Technical Note

Project: Proposed Residential Development off Pitt Street, Wombwell (2019/1117)

Title: Speed Survey & Updated Access Arrangements

Drawing Title
Swept Path Analysis Large Refuse Collection Vehicle Left Turn Out

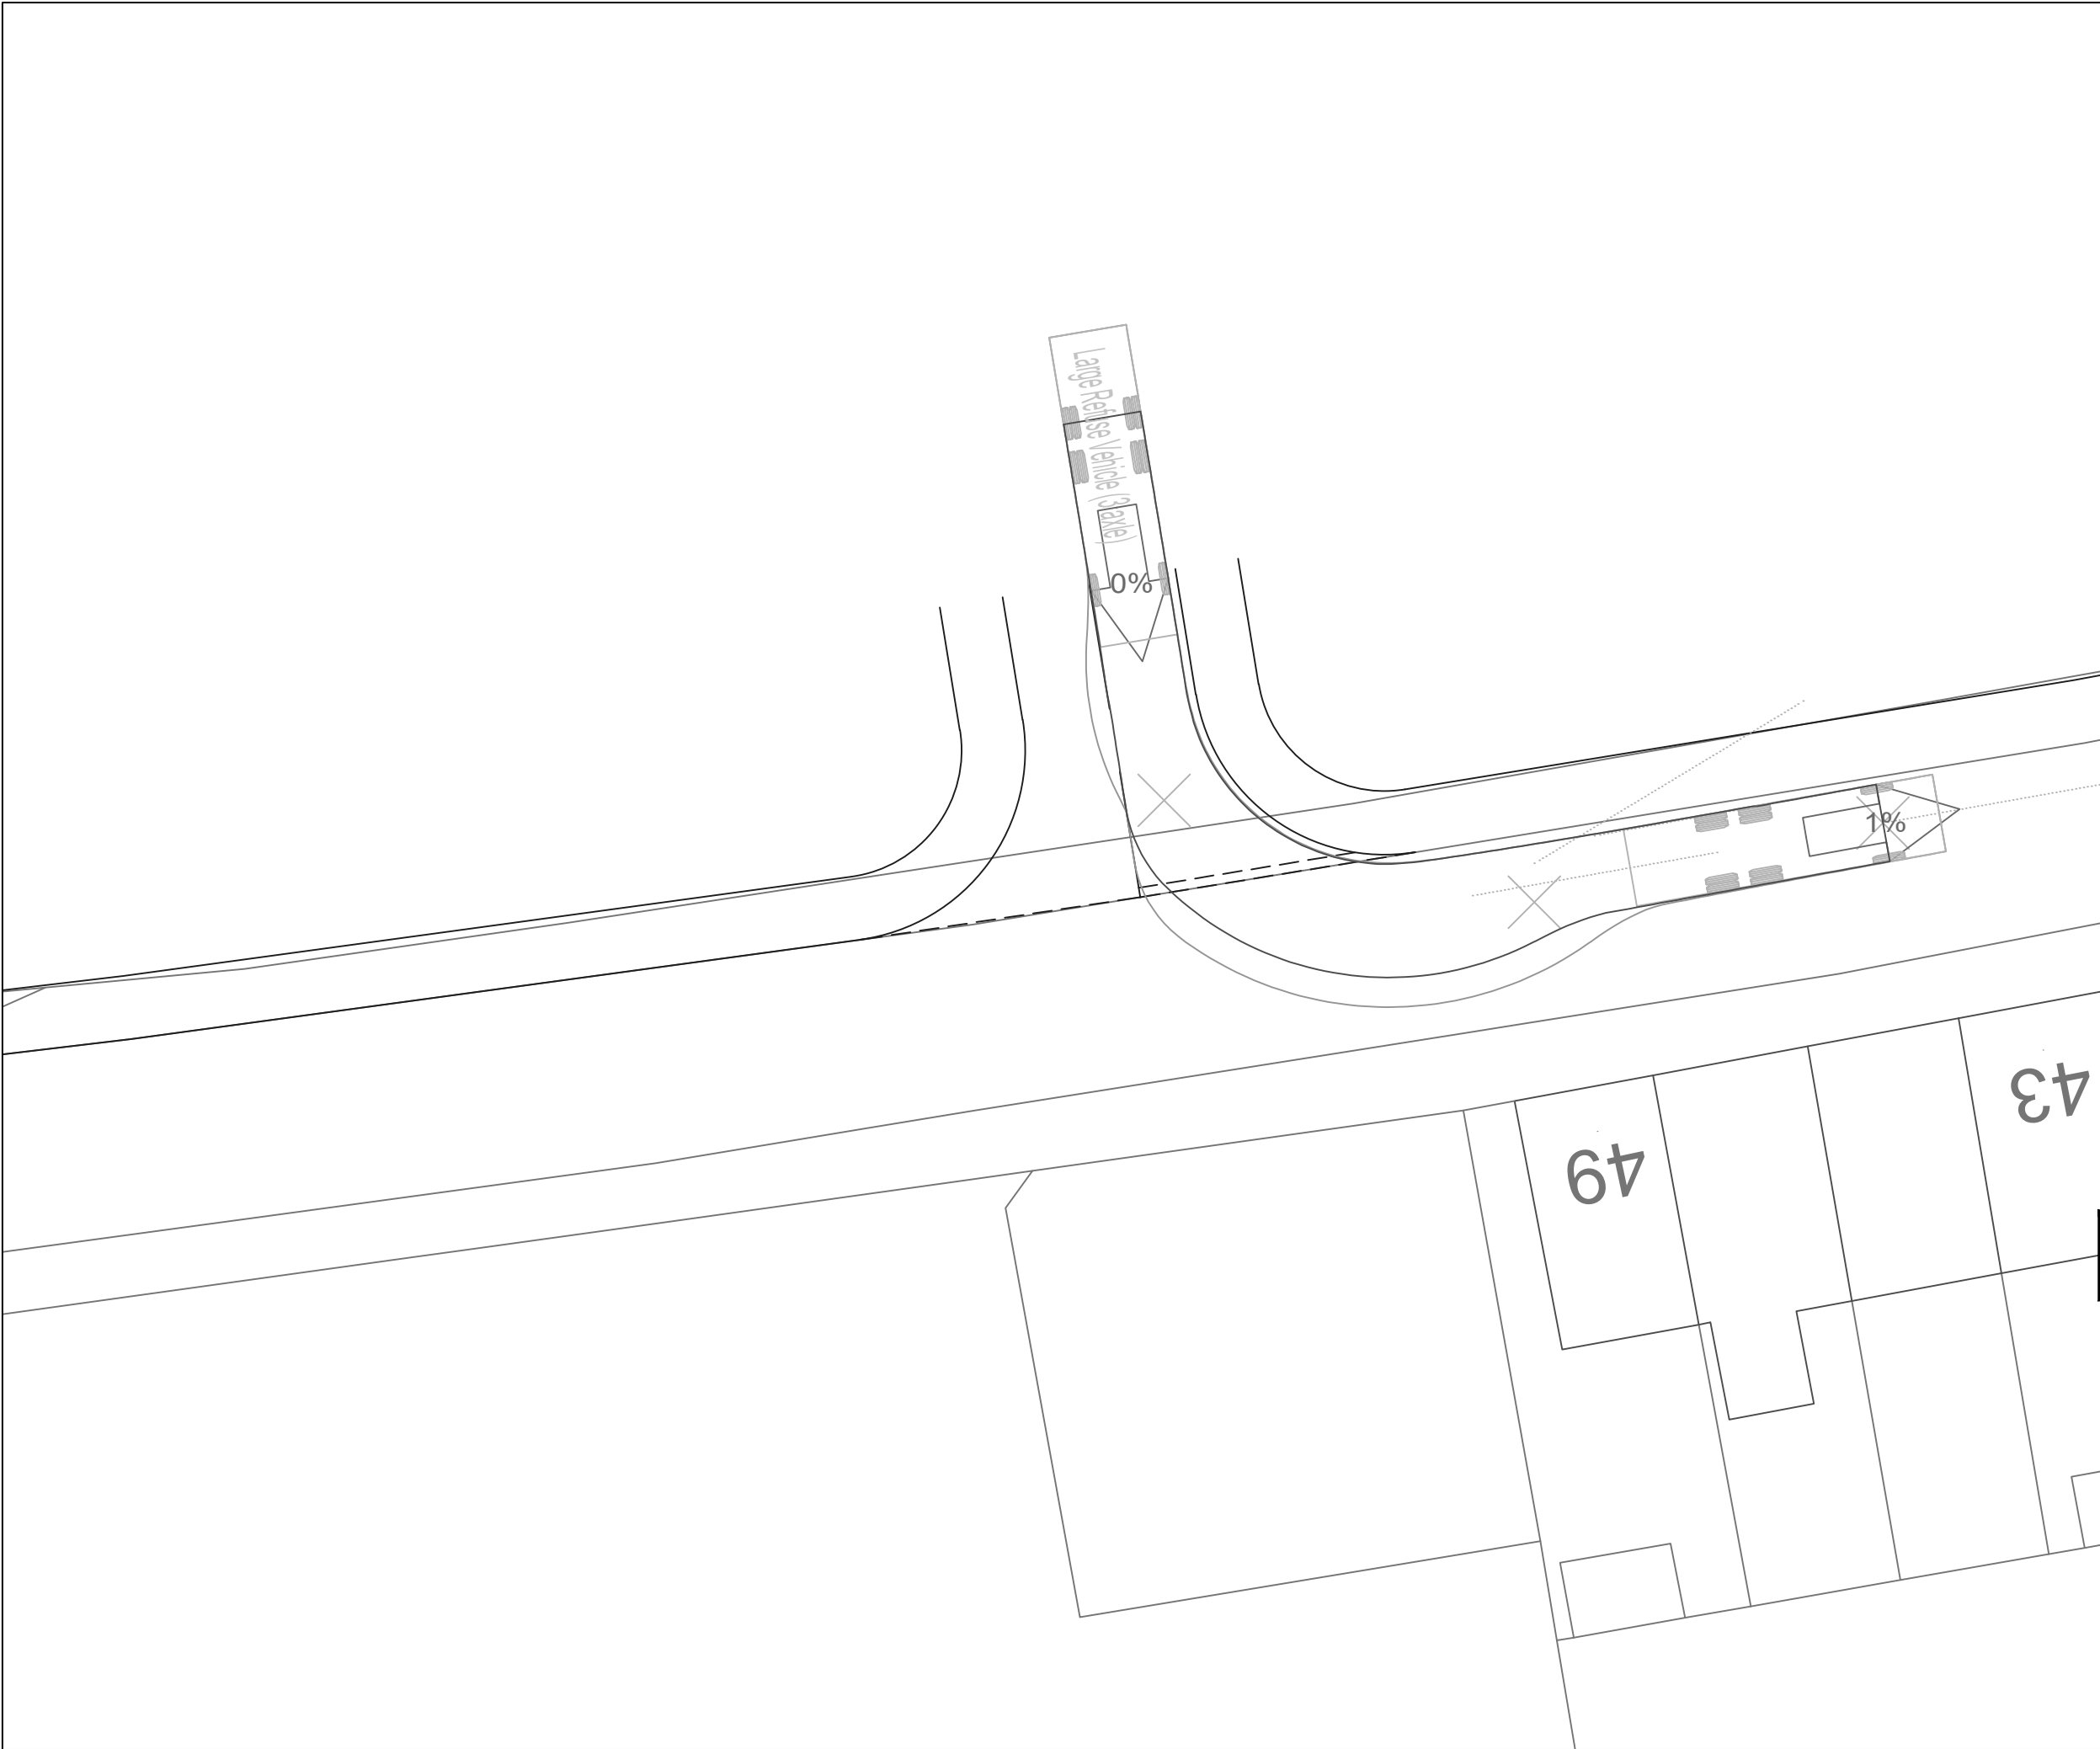
- 3.4 Swept paths analysis has been undertaken and is attached as Appendix D. This shows a large vehicle entering and exiting the site. It shows that large vehicles will be required to cross the centre line. This is supported by Manual for Streets (MfS) at paragraph 6.3.12 which states that tighter radii should be included to "...minimise the need for pedestrians to deviate from their desire lines...". The guidance goes on to state that this is because it is easier for pedestrians to establish priority when vehicles are travelling slowly around the smaller radii and also so that pedestrians do not have to look far behind to check for turning vehicles. MfS also states that "...with small corner radii, large vehicles may need to use the full carriageway width to turn...".
